A RESOLUTION RECEIVING ADDITIONAL PUBLIC COMMENTS ON A
REVISED DESIGN FOR SMITH LEVEL ROAD IMPROVEMENTS
Resolution No. 07/2010-11

RE: Smith Level Road (TIP #U-2803): April 27 and June 1, 2010, public hearing follow-up report

NCDOT is proposing a revised design for improvements to Smith Level Rd. from the Town limits south of Woodcrest Dr. to the Morgan Creek bridge (Bridge No. 88). The improvements comprise State Transportation Improvement Program (TIP) project #U-2803.

Figure 15: Design of the kerblines of the splitter island

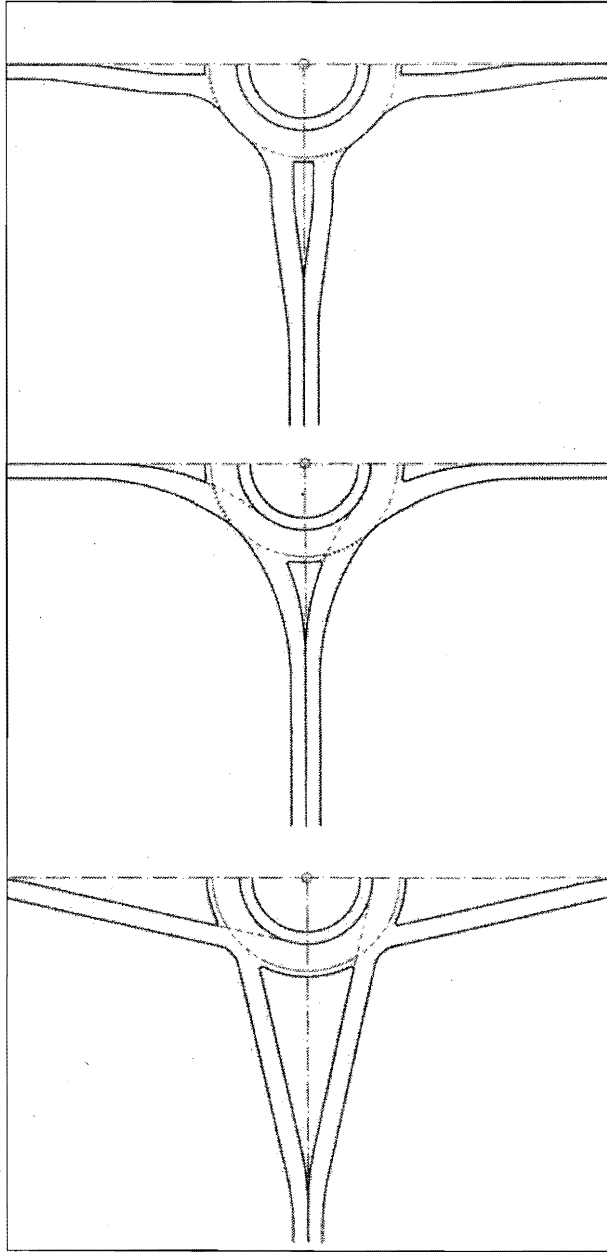
5. We are in favor of the construction of the roundabout, but we would like to see it modified in order to increase the deflection of the approaches (see Attachment A).

If there is a (very) wide splitter island or refuge ($> 3\text{m}$, which can be beneficial to the capacity, see section 4.7), it is advisable to increase the diameter of the roundabout in order to create enough deflection on entry. Up to 30 m, the outer radius of a roundabout has little influence on speed and therefore on road safety.

Summary of NCDOT response: NCDOT staff believe the roundabout splitter islands are appropriately designed. No changes have been made.

PROPOSED SMITH LEVEL ROAD TYPICAL SECTION

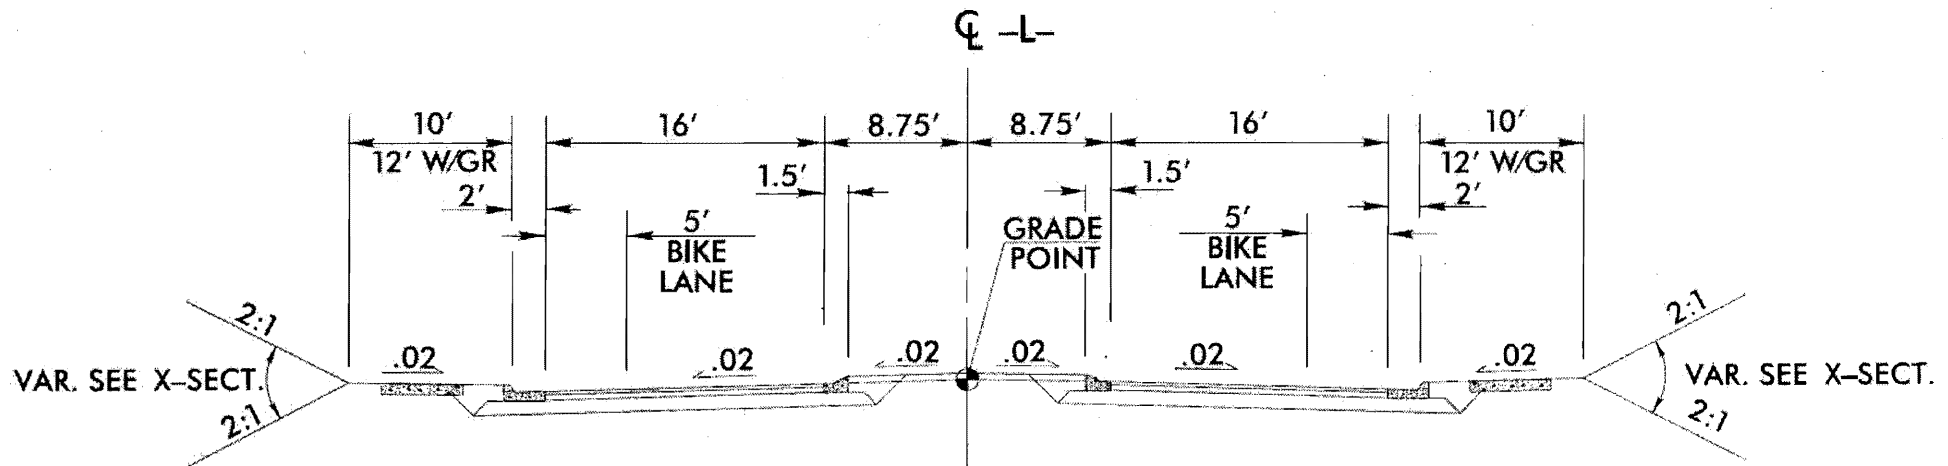
3. Is NCDOT willing to build sidewalks closer to road if the Town agrees to pay for the cost of moving the sidewalk if the Town requests future road improvements?

The cross-section for the two-lane, median-divided segment between the Morgan Creek Bridge and BPW Club Rd. has been modified to a curb-and-gutter design (*Attachment D*). It has been reduced in width by 26 ft., from 99.5 to 73.5 ft. *The curb-and-gutter design is being provided on the condition that the Town accepts responsibility for funding curb-and-gutter relocation in the event that the Town requests that the road be widened in the future.* The cost estimate for this relocation is \$240,000. This would be addressed in the Municipal Agreement for the project.

The reduction in width is made possible by the elimination of the vehicle recovery area.⁵ There is a 2-foot buffer between back of curb and sidewalk. Bike lane and sidewalk width (5 ft.), vehicle lane width (11 ft.), and median width (17.5 ft.) have not changed. (Median width is discussed more below.)

In response to the possibility of reducing the median width, for safety reasons, medians allowing left turns must be wide enough to accommodate the width of vehicles. NCDOT guidelines stipulate a minimum median width of 16 ft. if it will have directional

crossovers like the one currently proposed at Willow Oak Ln.⁶ For the two-lane, divided section, NCDOT is proposing a 17.5 ft. median width (*Attachment D*).

Summary of NCDOT response: Yes. The cross-section for the two-lane, median-divided section has been modified to curb-and-gutter and reduced in width, contingent on such an agreement.
